AMENDMENTS TO THE DRAWINGS:

Please note the proposed corrections to Figs. 1-7, 11 and 25 as shown in red on the copies of the drawings attached herewith. Specifically, applicant proposes to amend the drawings as follows:

FIG.1
Prior Art

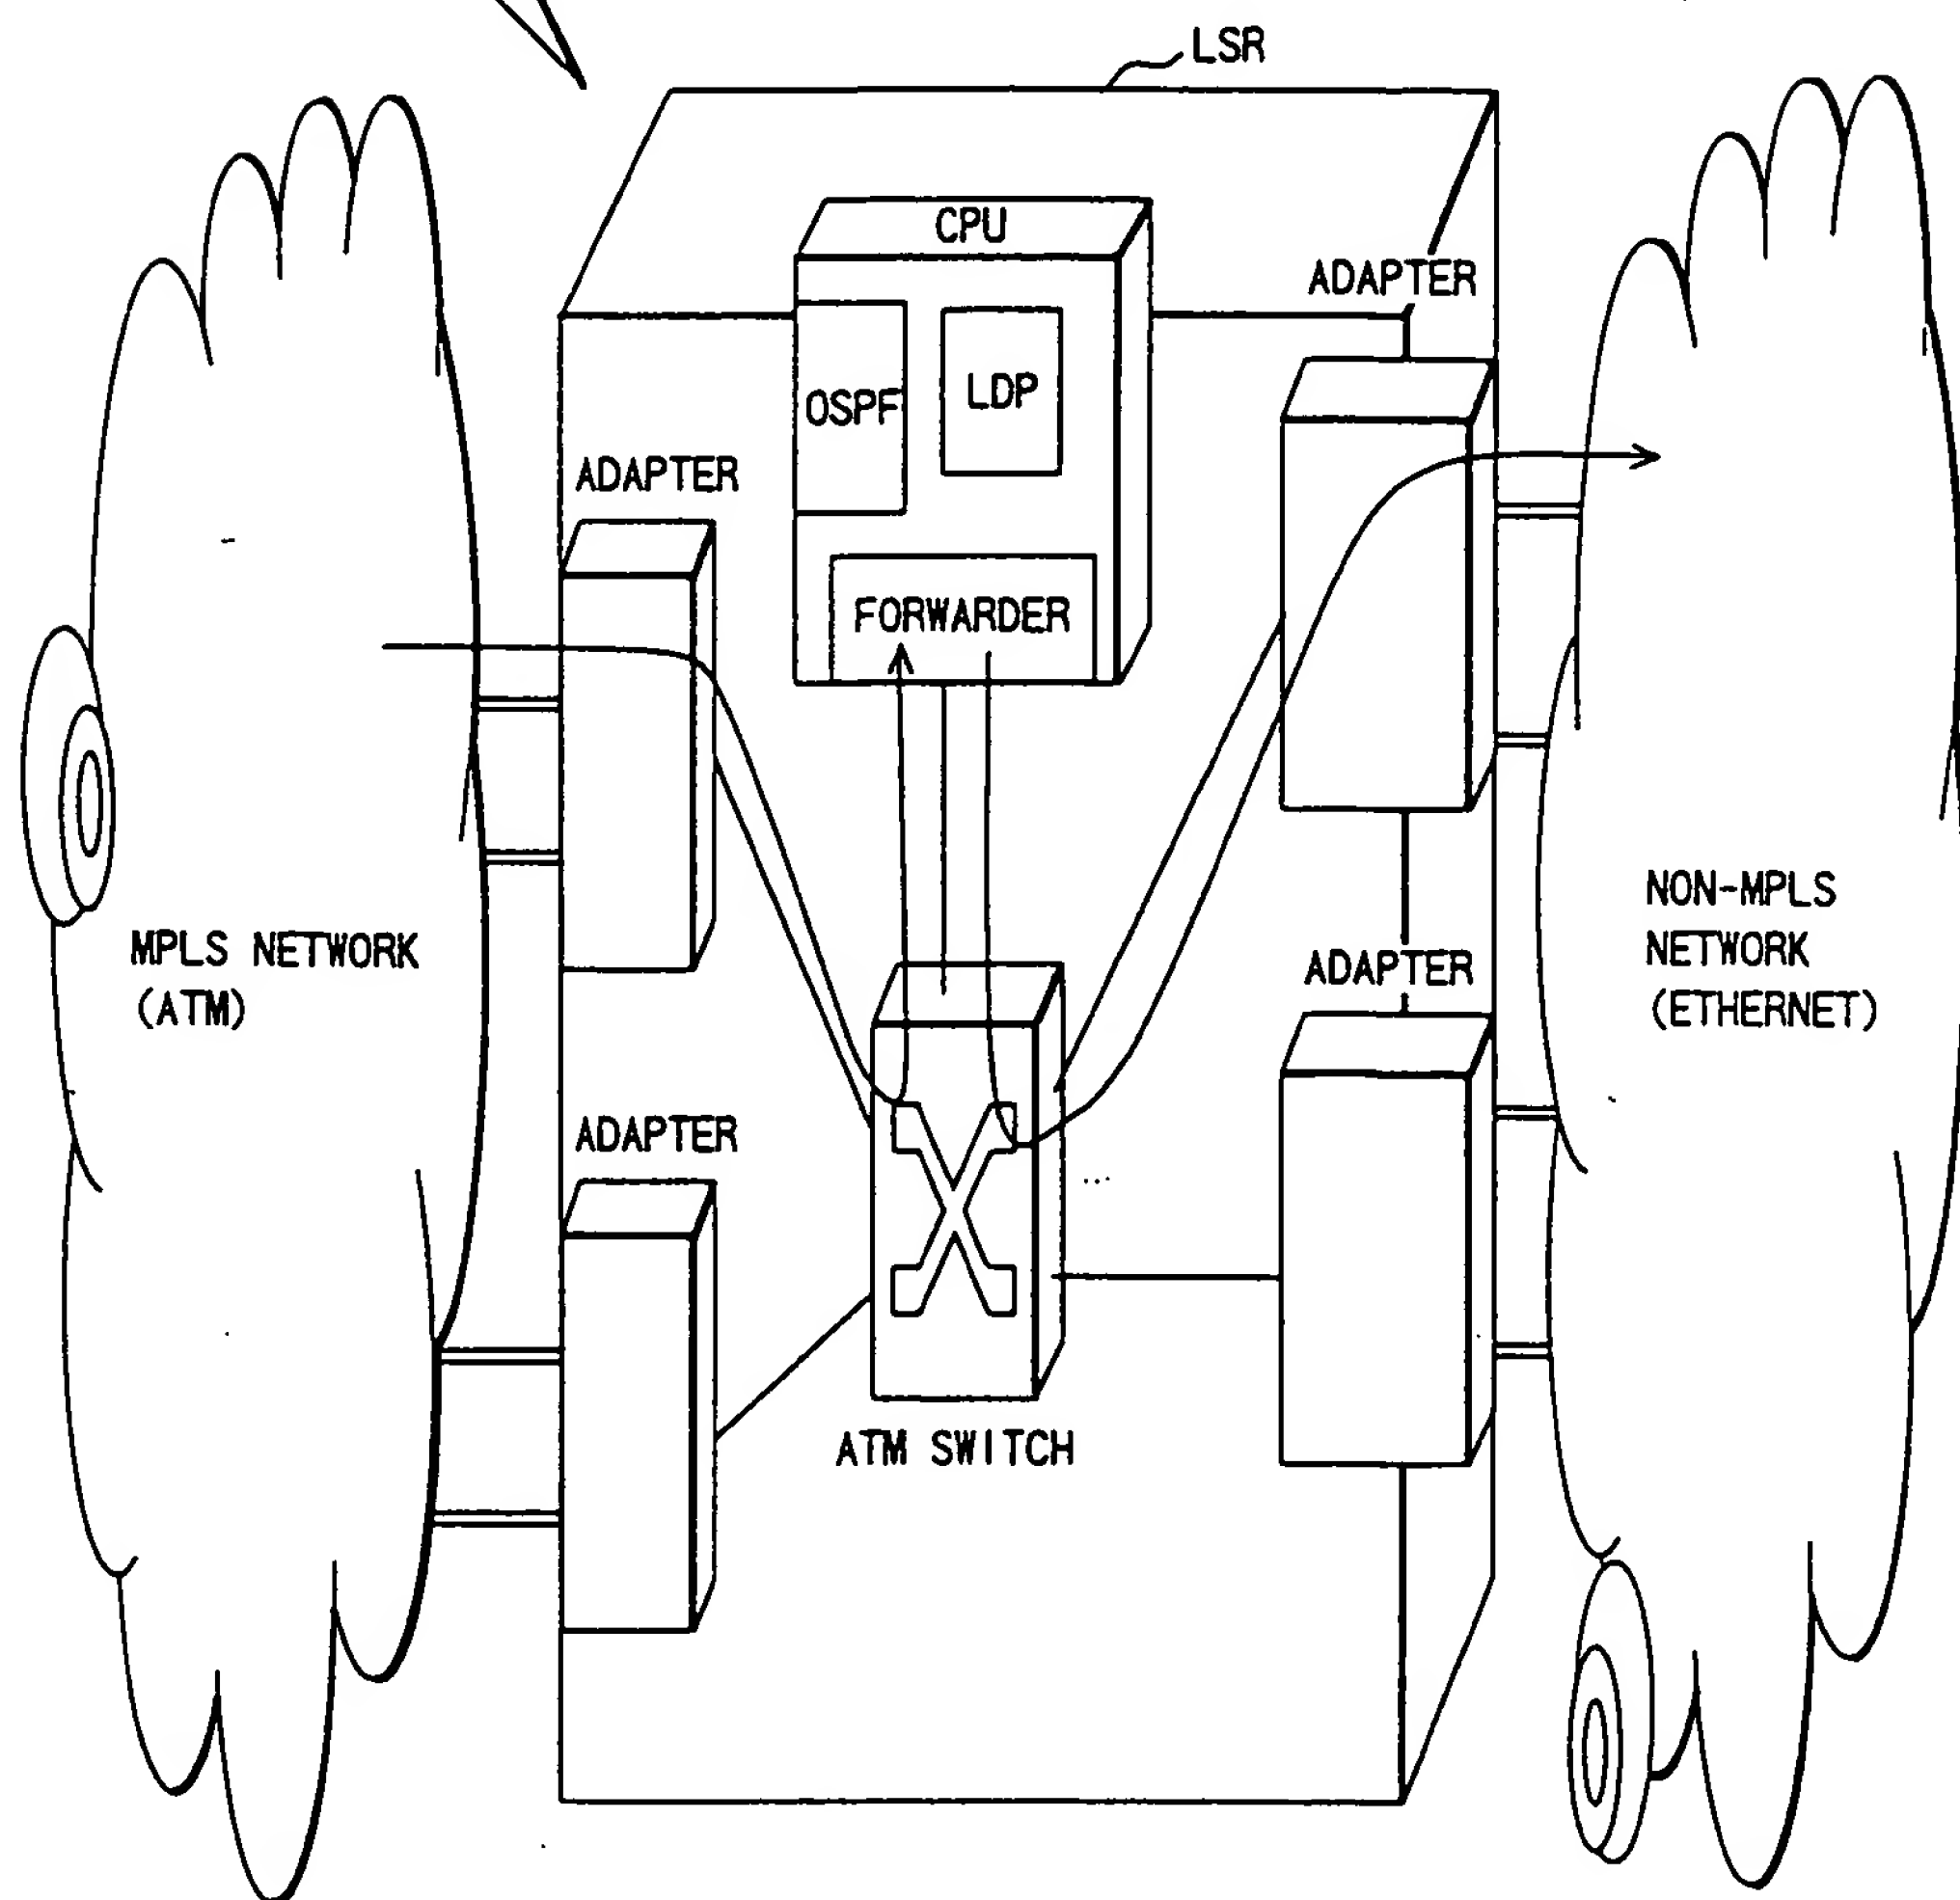
- (1) In FIGS. 1 – 7, add “PRIOR ART”,
- (2) In FIGS. 5 – 7, change “LABAL” or “LABLE” to --LABEL--,
- (3) In FIG. 11, interchange “PORT GROUP 3” and “PORT GROUP 4”, and
- (4) In FIG. 25, change “80 FORWARDER” to --80 FORWARDER (X)--.
